**Re:** Environmental Assessment Exhibition – Royal Far West Expansion Concept Plan,  
South Steyne and Wentworth Street Manly. (MP10\_0159)

## **MANLY COUNCIL SUBMISSION**

TO THE DEPARTMENT OF PLANNING AND INFRASTRUCTURE,  
METROPOLITAN AND REGIONAL PROJECTS SOUTH  
IN RESPONSE TO THE ENVIRONMENTAL ASSESSMENT EXHIBITION SUBJECT:  
**ROYAL FAR WEST EXPANSION CONCEPT PLAN,**  
SOUTH STYNE AND WENTWORTH STREET MANLY (MP10\_0159)

DA Working Group of the Heritage Committee  
3 November 2011

15 South Steyne, 2006

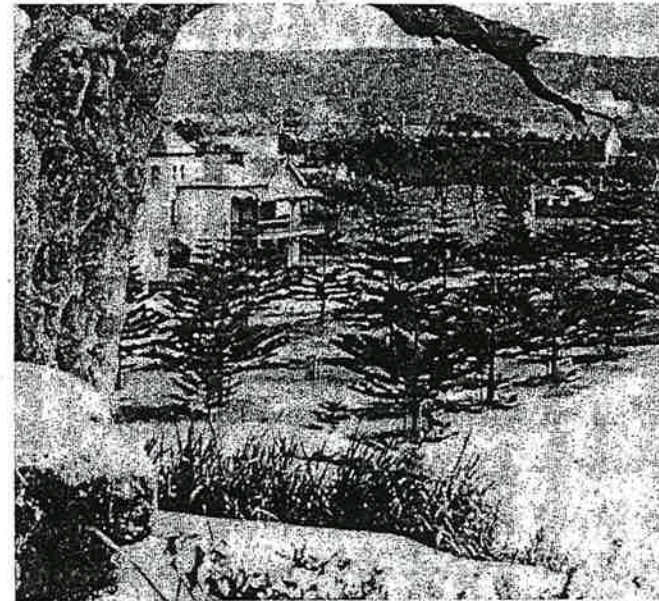
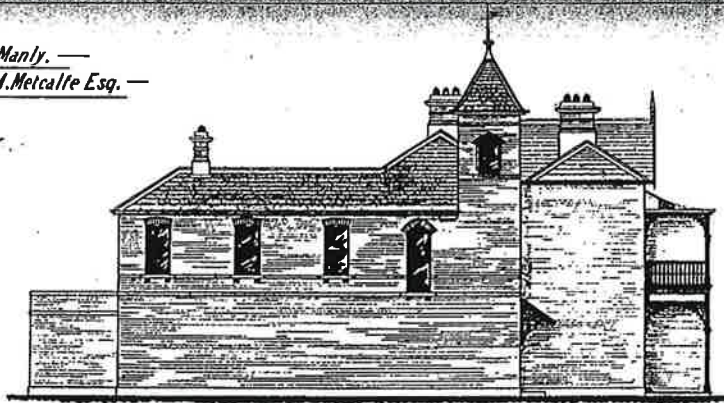
1. The proponent is to be commended on the proposed retention of Drummond House and Tranby / Latrobe, the listed Heritage items.
2. The proponent should ensure the full restoration of both properties. The detailed restoration of the Tranby/ La Trobe pair (c.1883) is essential, in particular the reinstatement of the tower roof, roof details and verandahs. (see attached photos and plans for 15 South Steyne).
